GROUP	MODEL
ELE	2017MY Cadenza (YG) Sportage (QL)
NUMBER	DATE
254	May 2022

TECHNICAL SERVICE BULLETIN

AIRBAG CONTROL UNIT (ACU) INSPECTION & REPLACEMENT

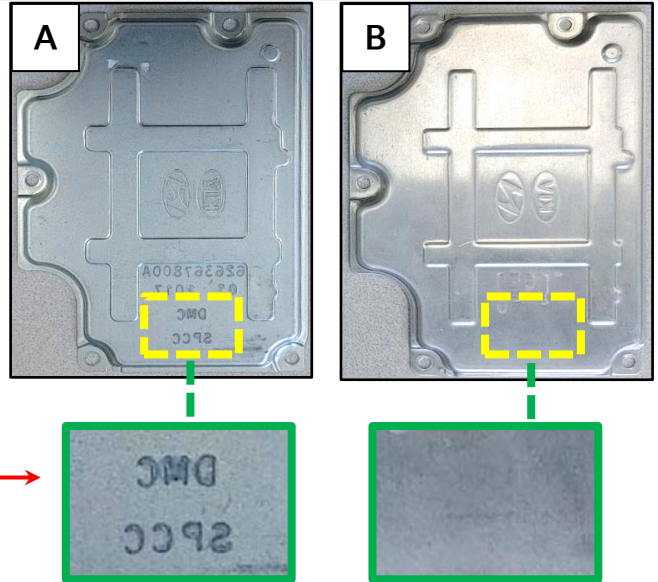
ⓘ IMPORTANT
After removing the old ACU, drill a hole through the center of the removed part and DO NOT re-use.

NEW Part Identification:

- A. Engraved initials “DMC” (backwards)
- B. No engraved initials

OLD Part Identification:

- The old part will have engraved initials “AQ” (backwards), as shown.
